ADDENDUM NO. 1
Bid Due Date: 6/3/2026

Dated: 5/20/2026

McPherson Square Library Renovations and Park Improvements

**McPherson Square Library Renovations and Park Improvements RFP
Answers to Bidder's Questions
Addendum #1 5/20/26**

DRAWING TITLE
FURNITURE PLANS

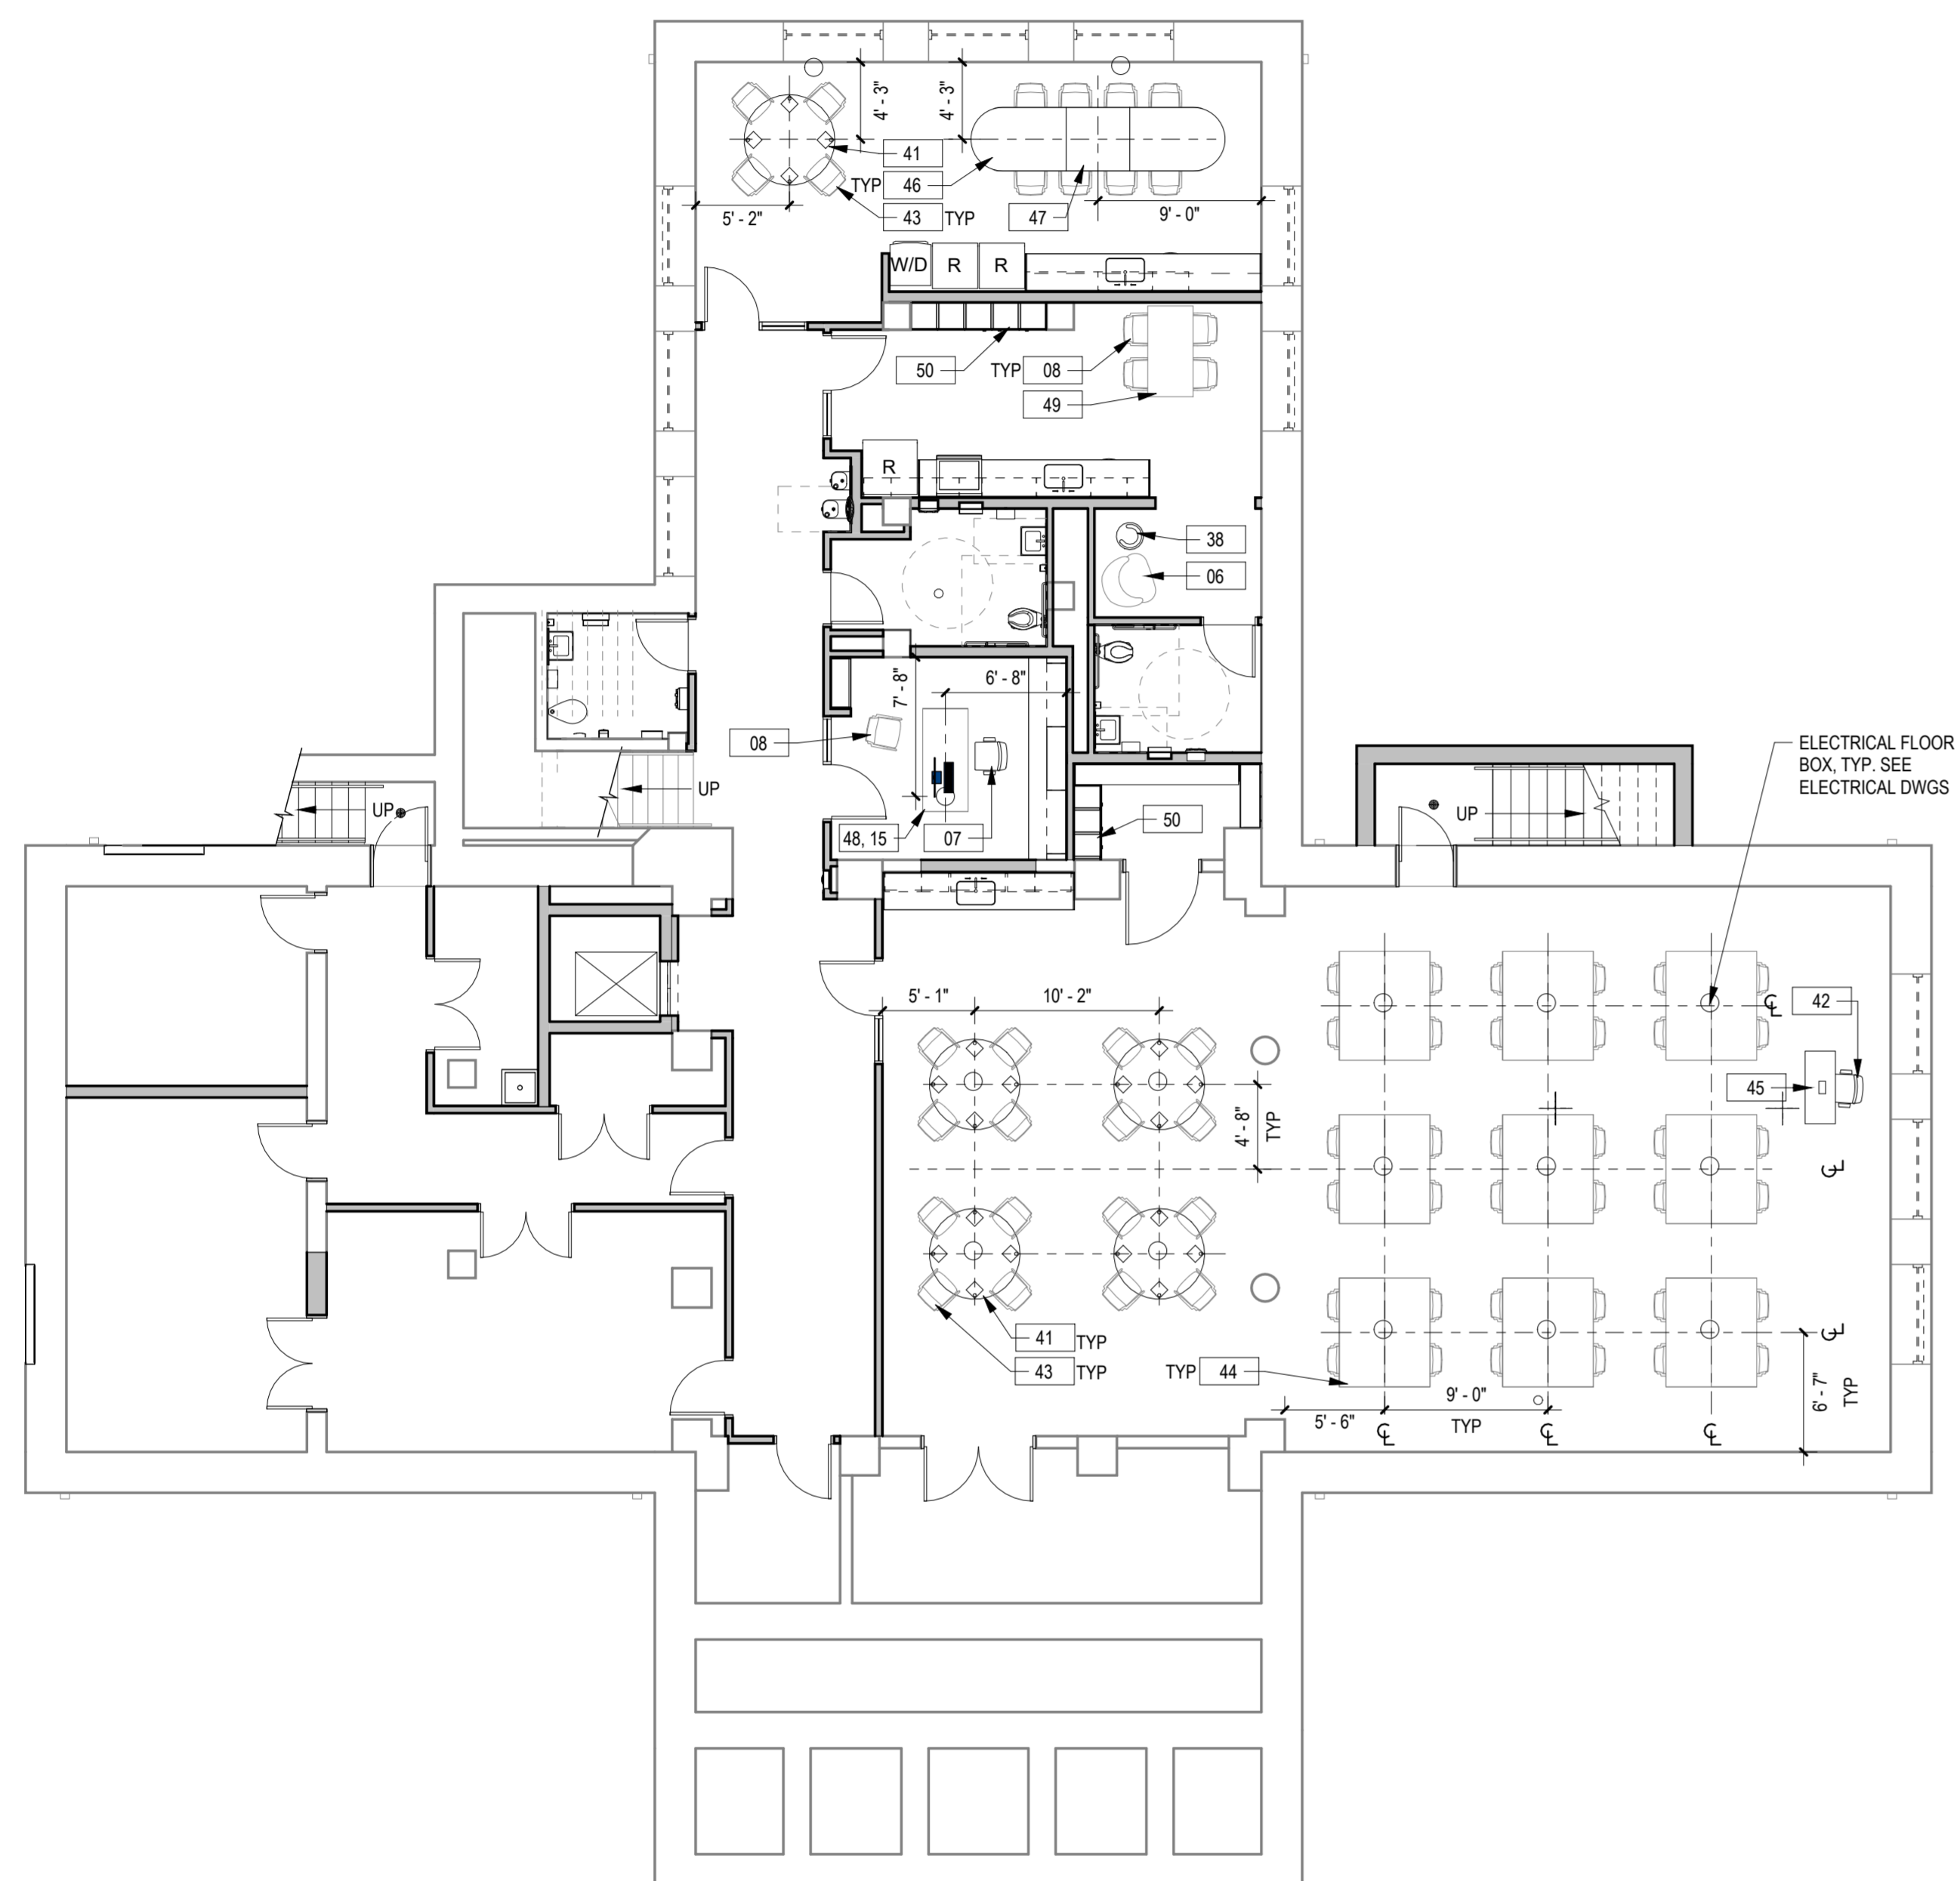
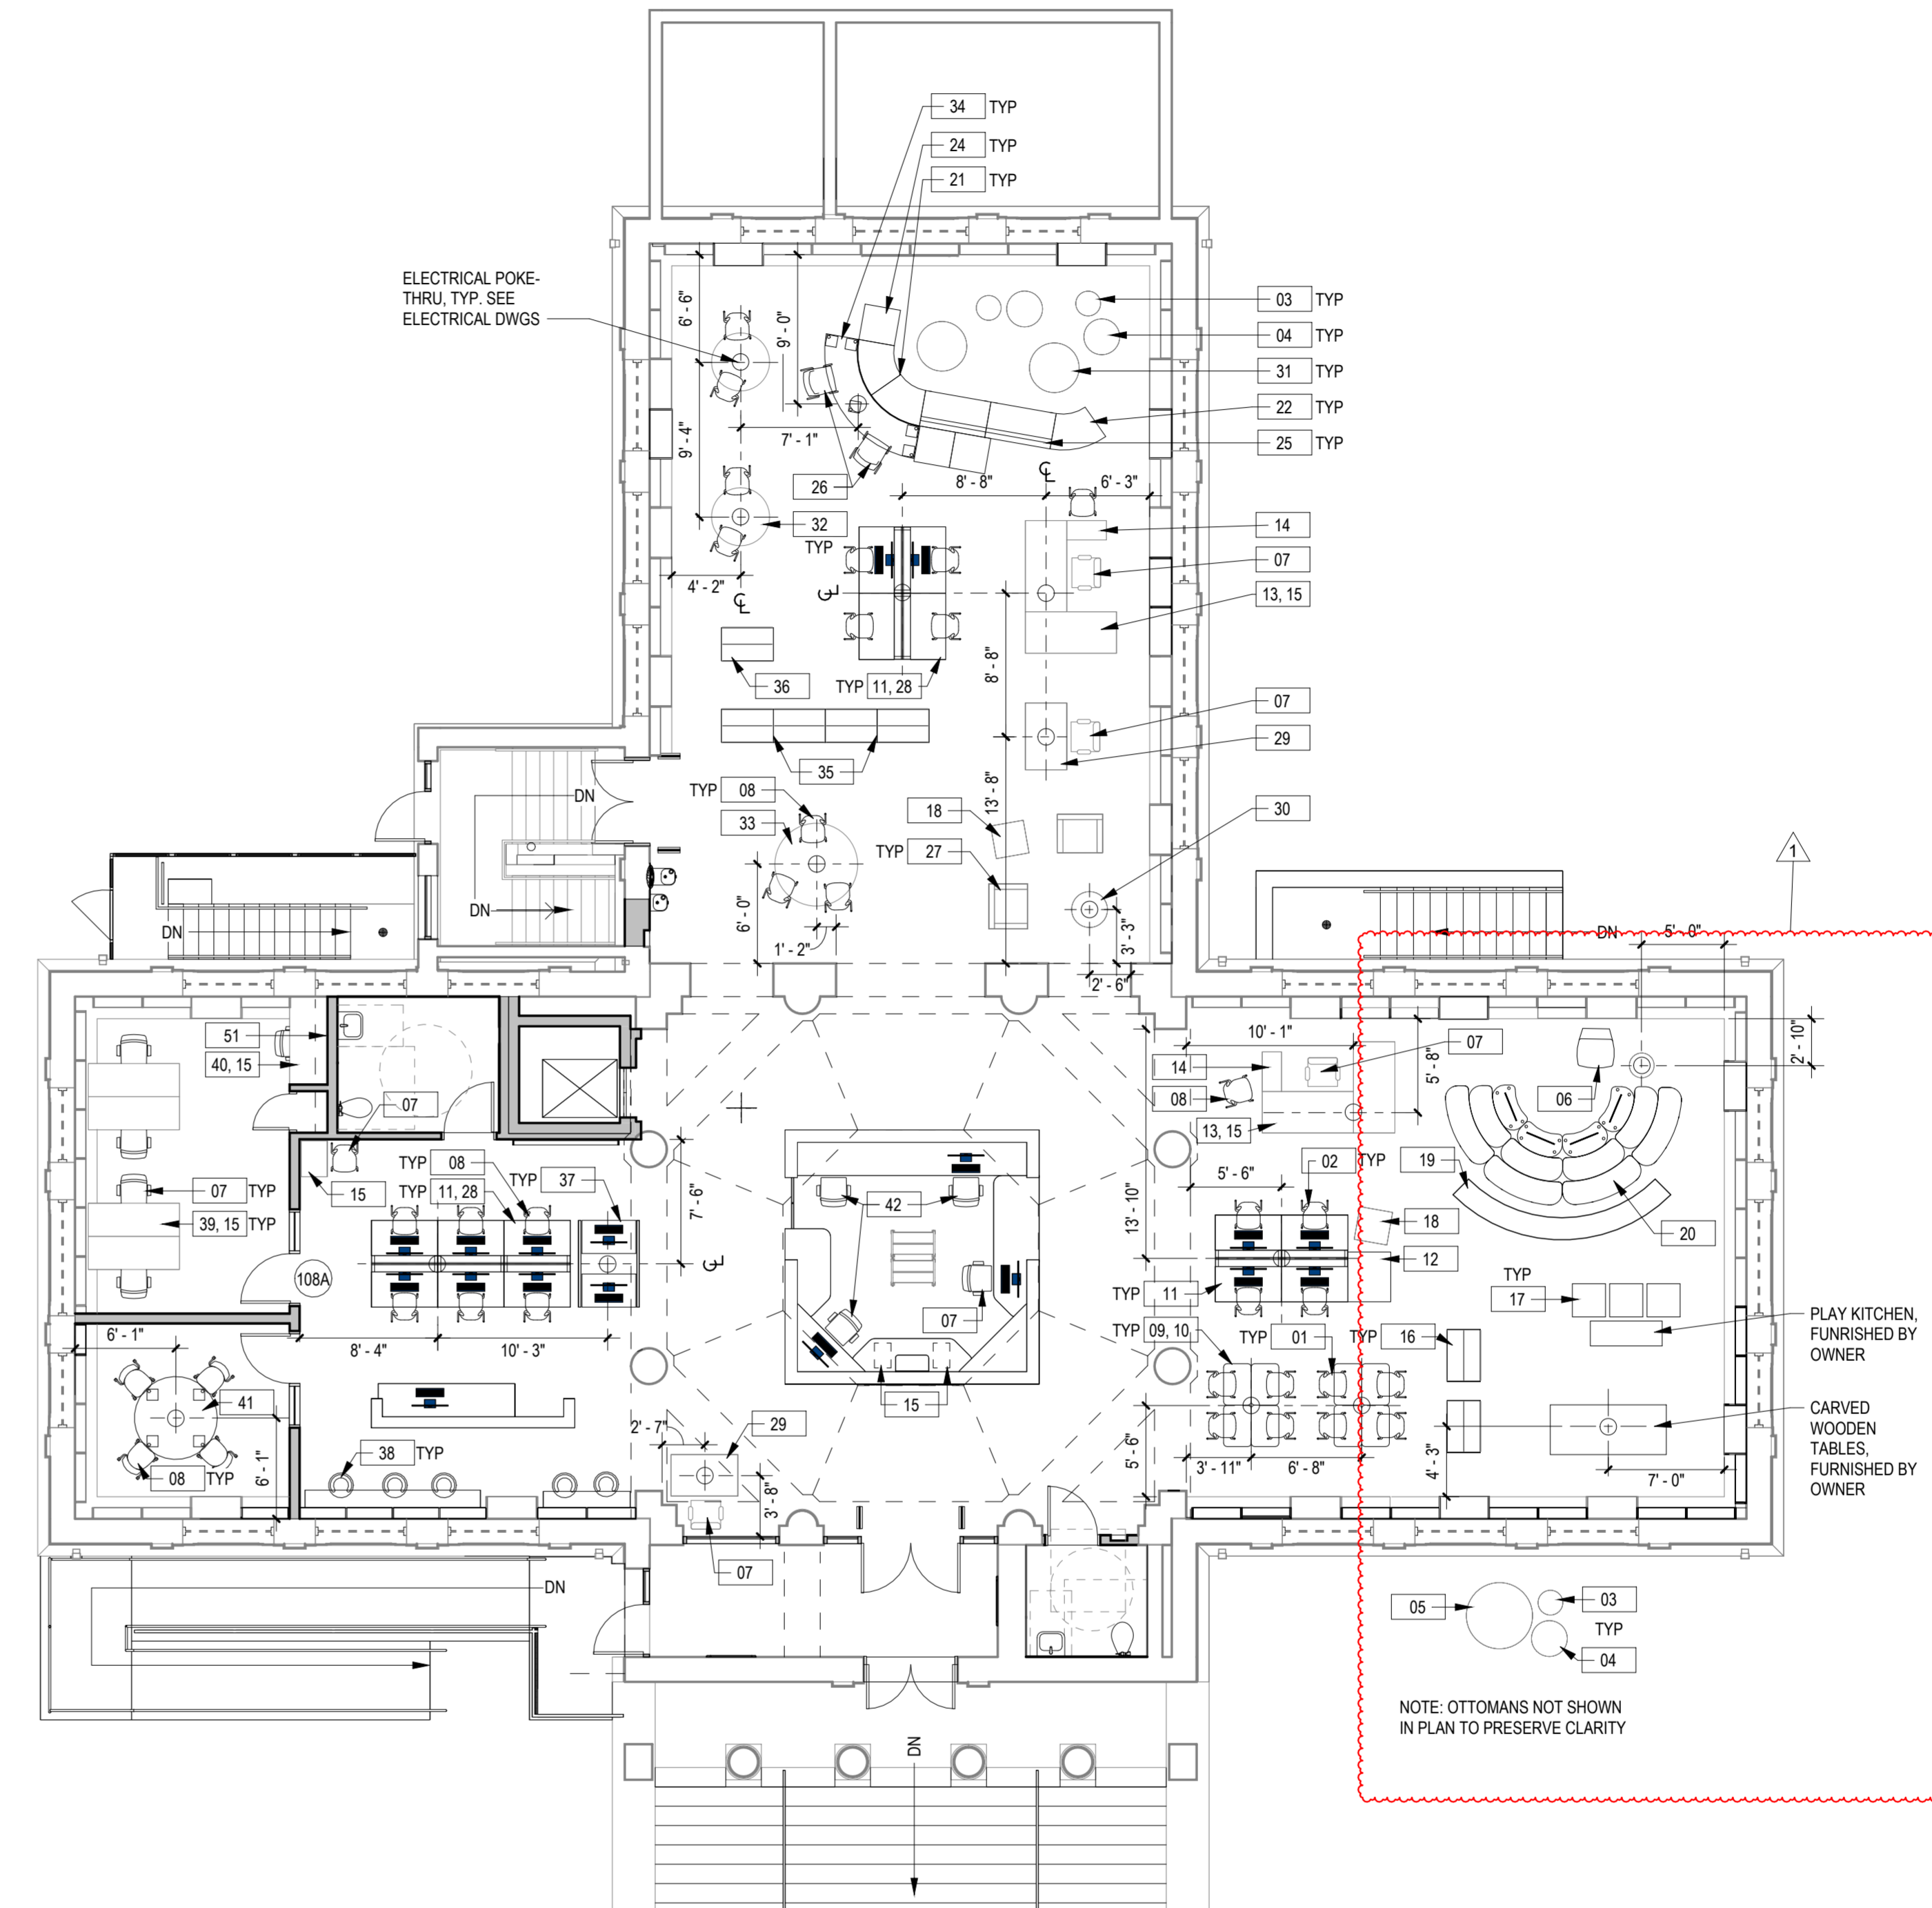
51. Please provide notes for the Furniture Plans to match the callouts on the drawing per A11.1.

Response: Refer to furniture schedule on A10.2.
